# SAN FRANCISCO PLANNING DEPARTMENT

## Memo to the Planning Commission

HEARING DATE: JULY 26, 2018  
Continued from the May 24, 2018 Hearing

*Date:* July 19, 2018  
*Case No.:* 2016-015727DRP-02  
*Project Address:* **556 27th STREET**  
*Zoning:* RM-1 (Residential-Mixed, Low Density)  
40-X Height and Bulk District  
*Block/Lot:* 6581/080  
*Project Sponsor:* Handel Architects  
735 Market Street, 2<sup>nd</sup> Floor  
San Francisco, CA 94103  
*Staff Contact:* Chris Townes – (415) 575-9195  
[chris.townes@sfgov.org](mailto:chris.townes@sfgov.org)  
*Recommendation:* **Take DR and approve with modifications.**

Area Reduction 1,240 S.F.

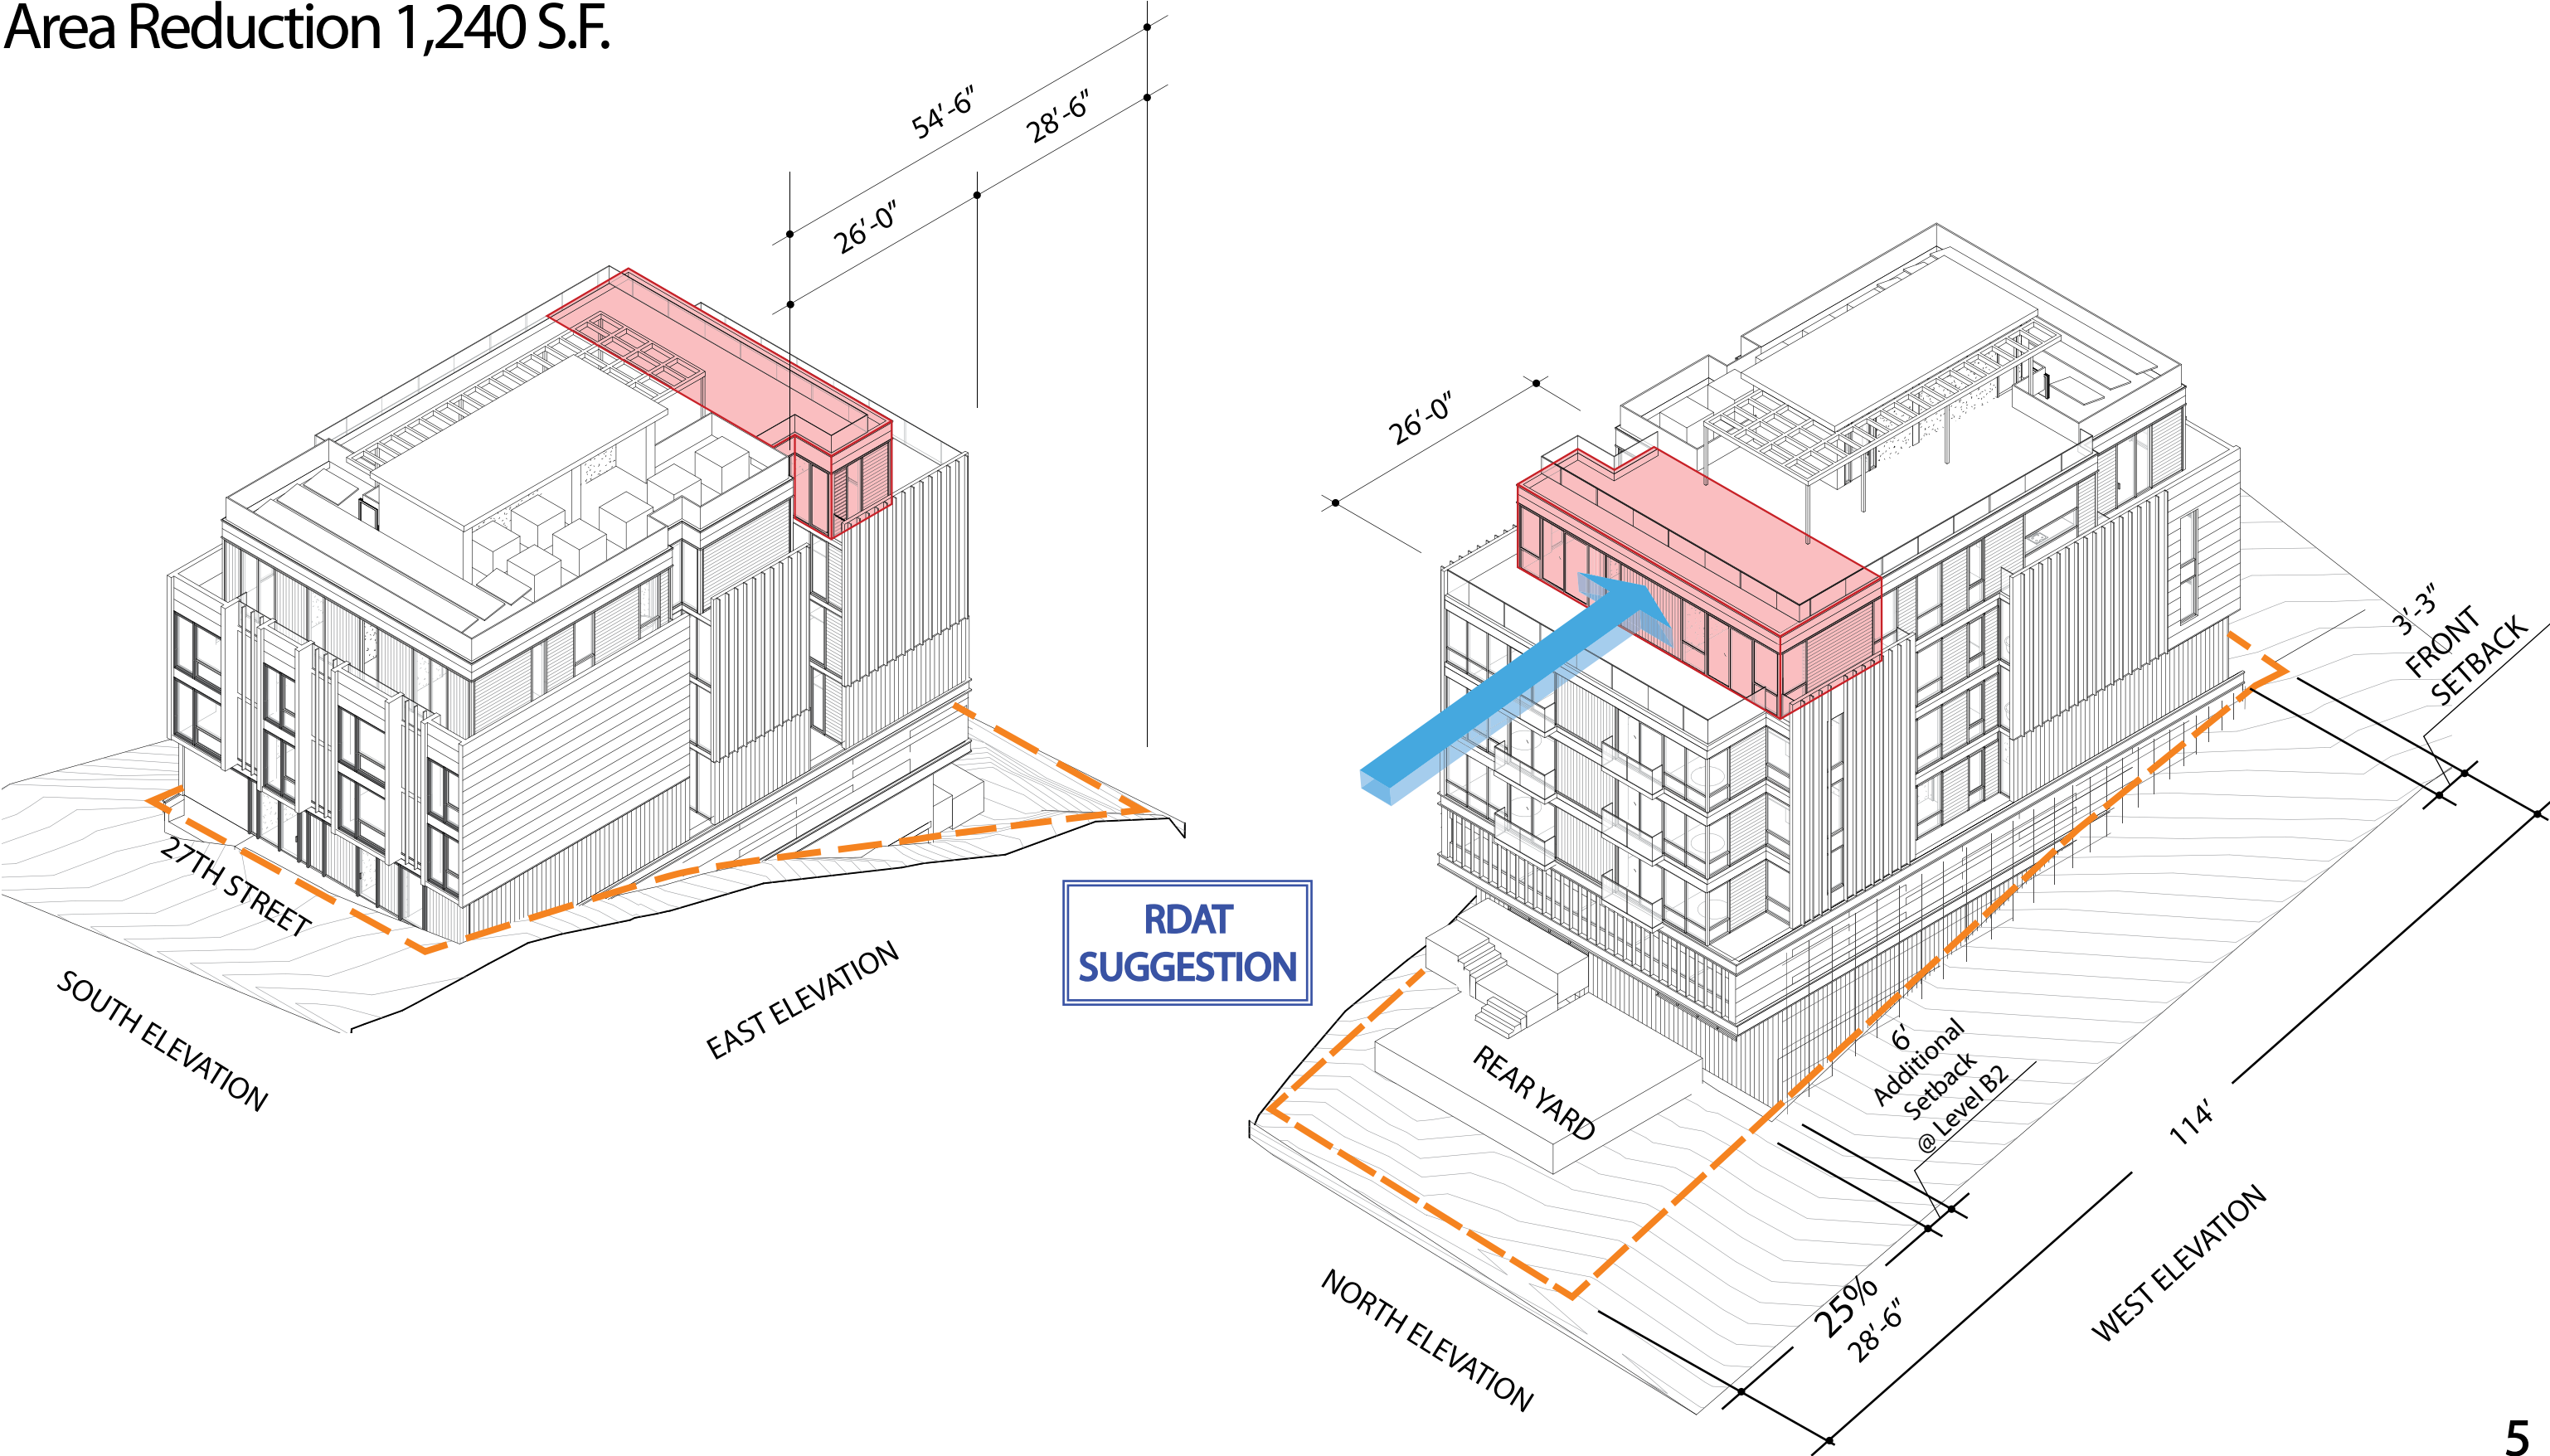
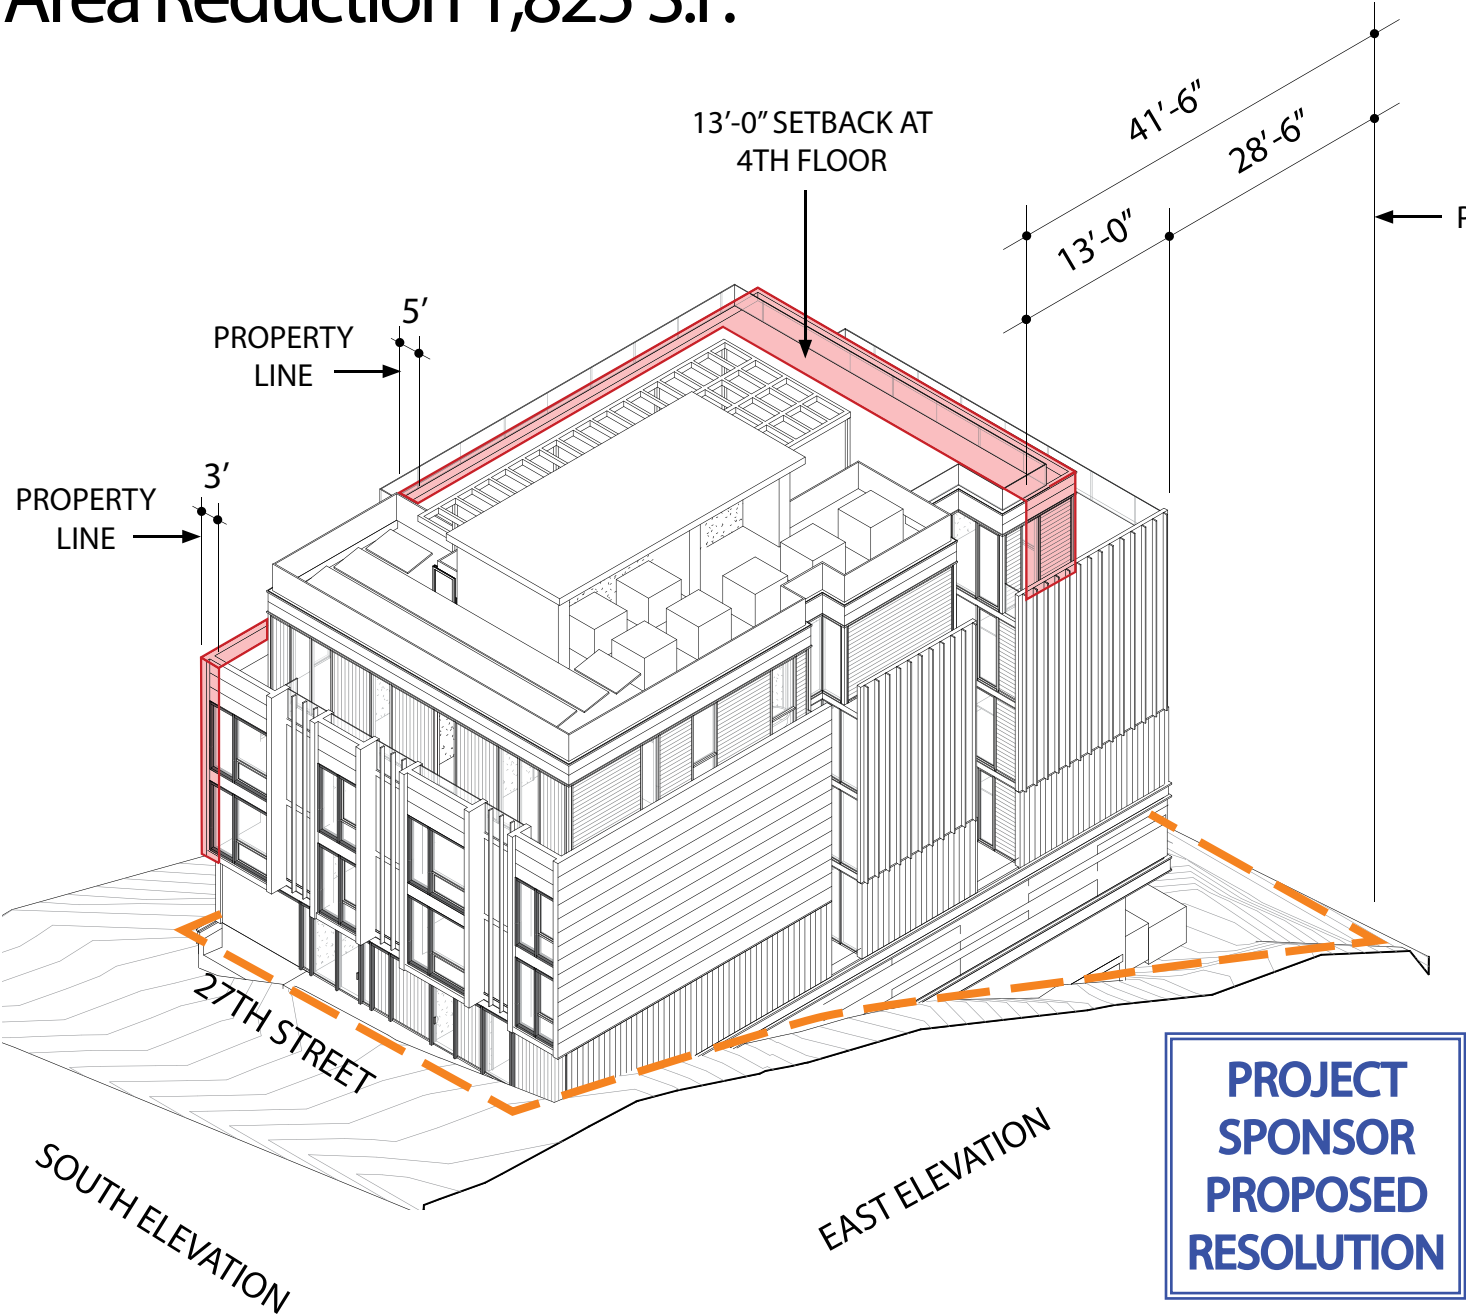
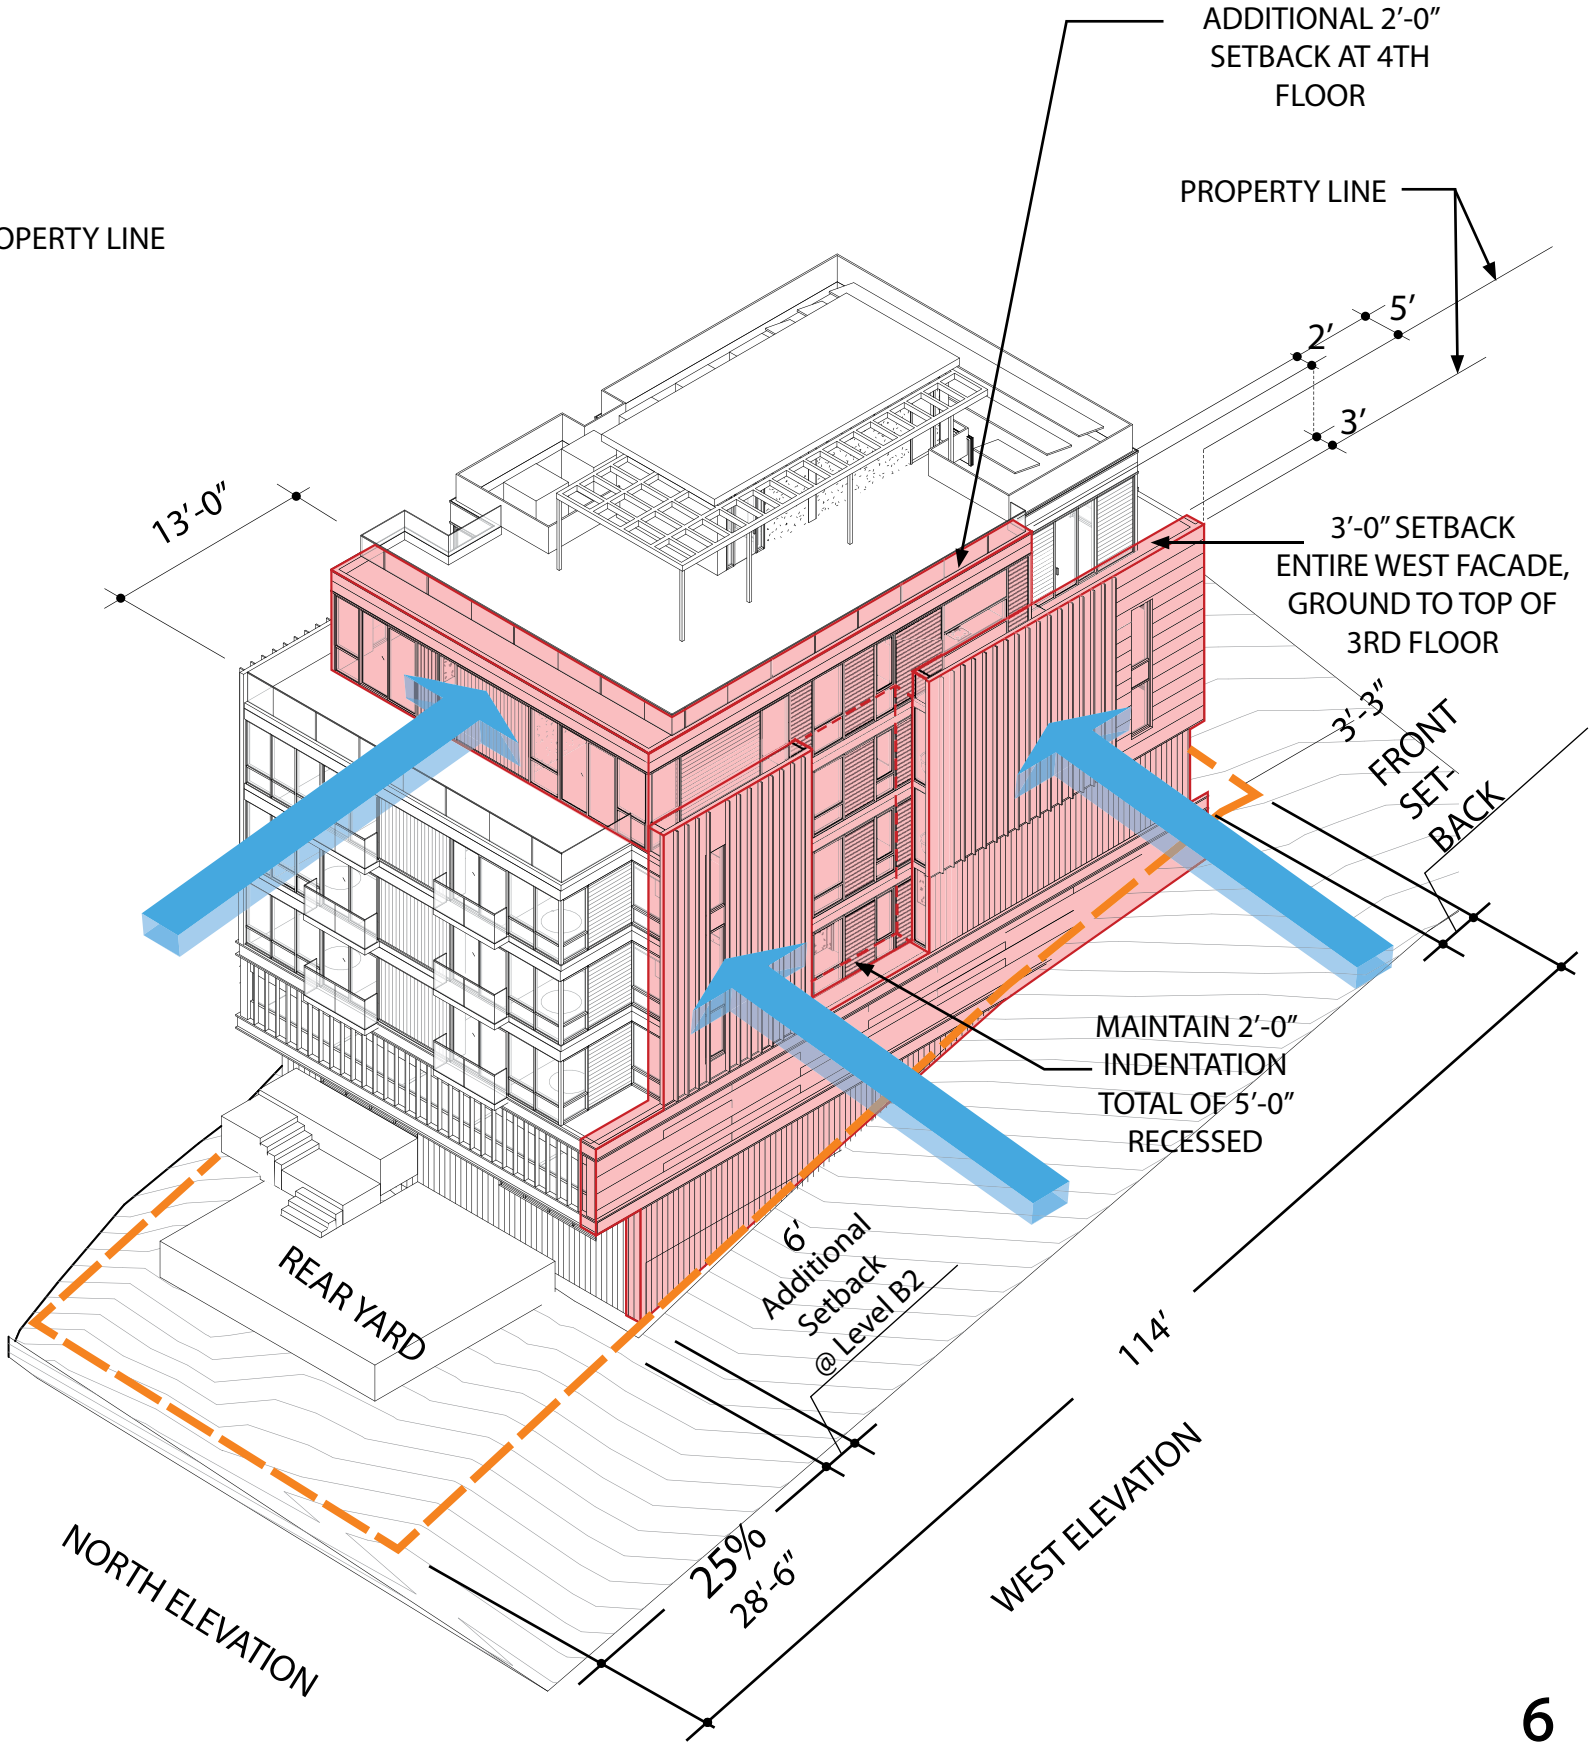
# Mitigation 2: Massing Reduction Per RDAT Comments (POST DR FILING) RECEIVED 4/24/2018

# Mitigation 3: Sponsor Proposed Resolution 5/4/2018

**PROJECT  
SPONSOR  
PROPOSED  
RESOLUTION**

Massing Comparison  
From Backyard

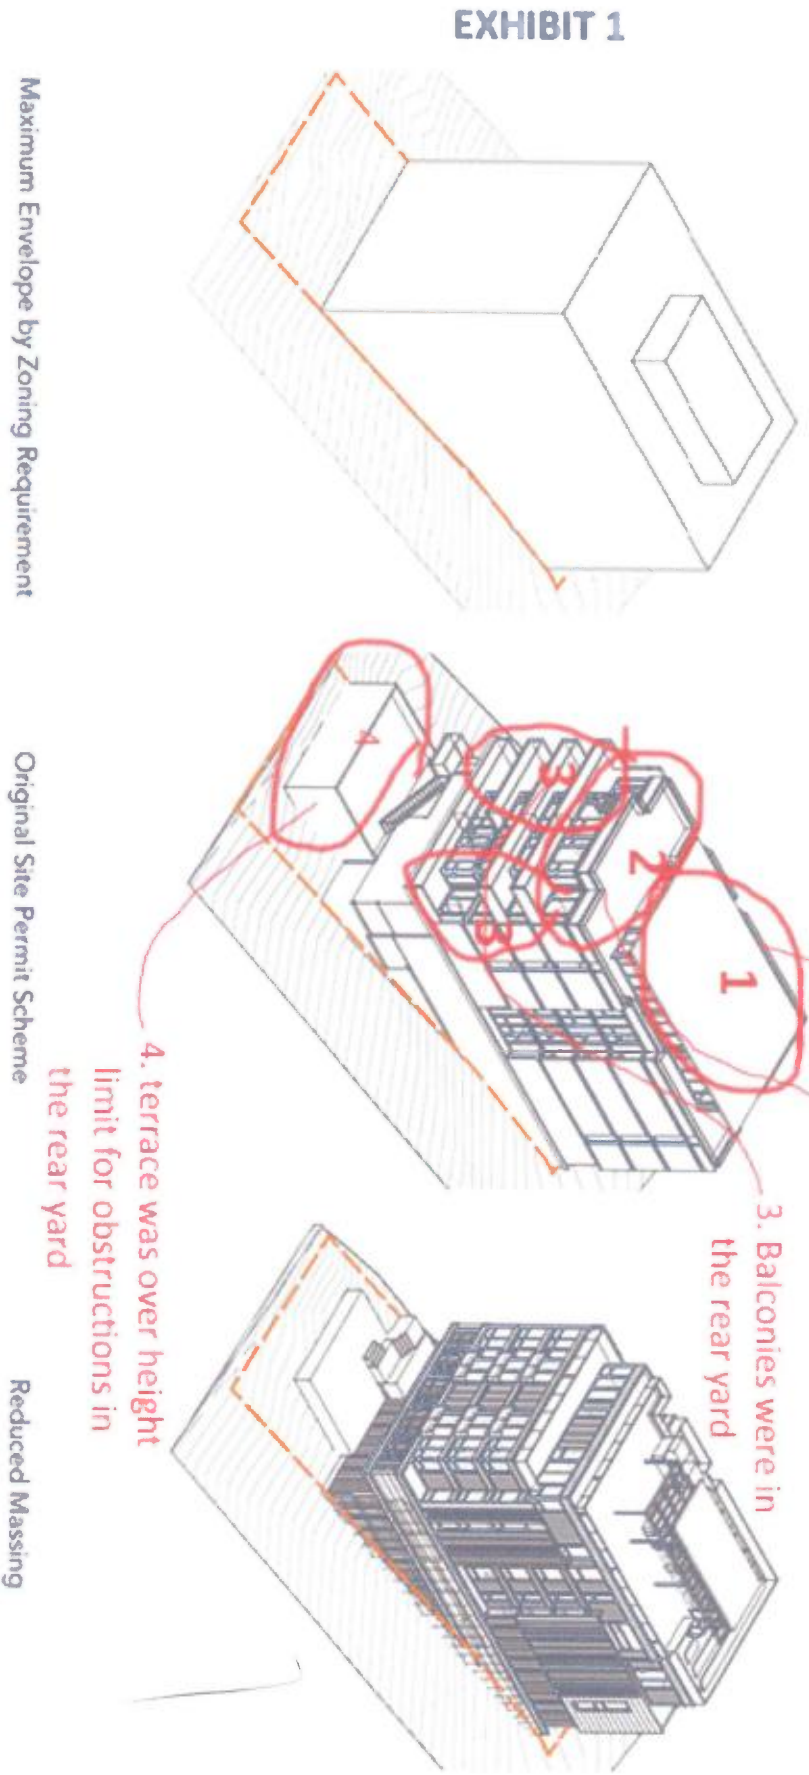
Sponsor's graphic showing massing reductions: neglects to say nearly all reductions were because original proposal exceeded quantitative code requirements. "Significant sculpting" mandated by the RDT NEVER happened. Instead, code violations were corrected.

EXHIBIT 5

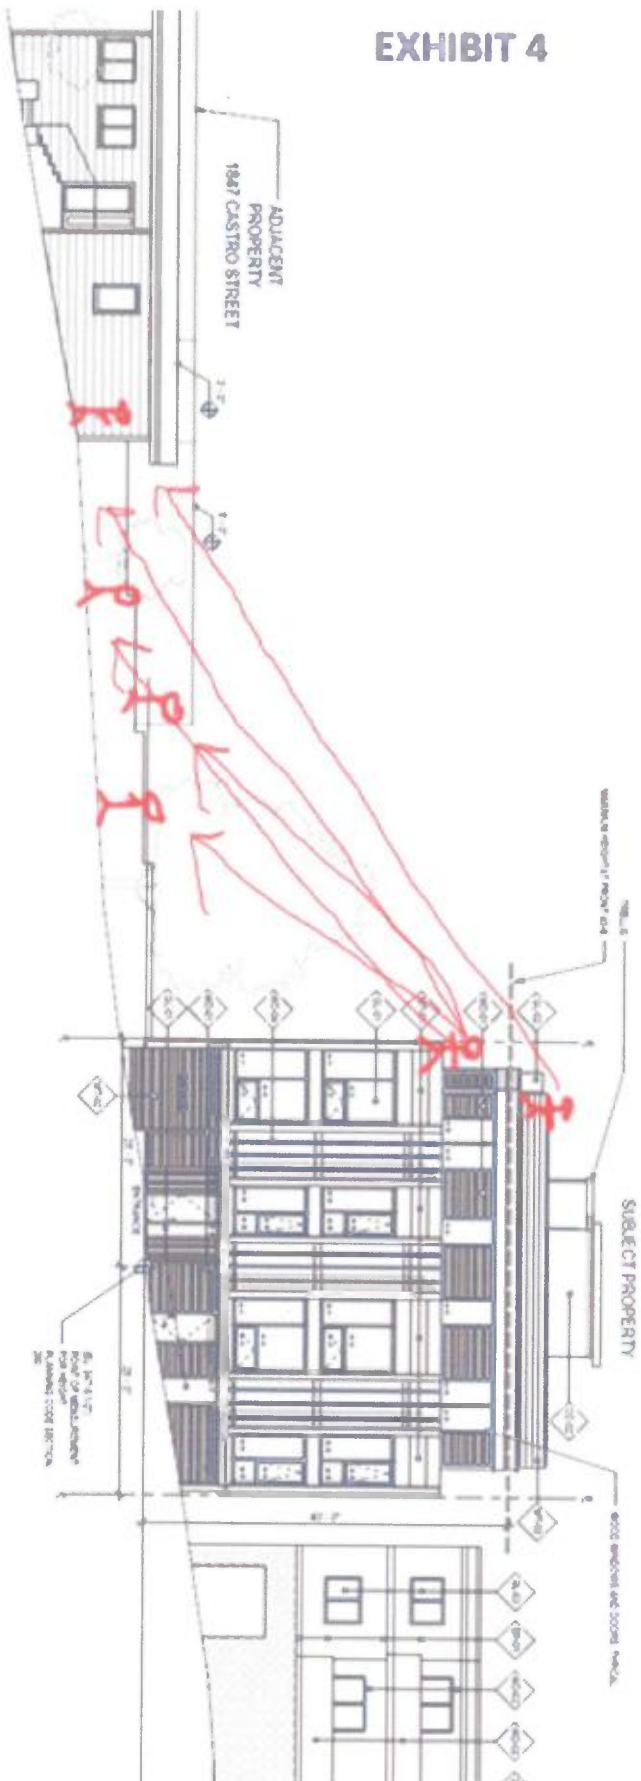
Sight lines from penthouse deck and roof deck to rear windows and rear yards of homes on Castro and side windows on adjacent rent-controlled apartments.
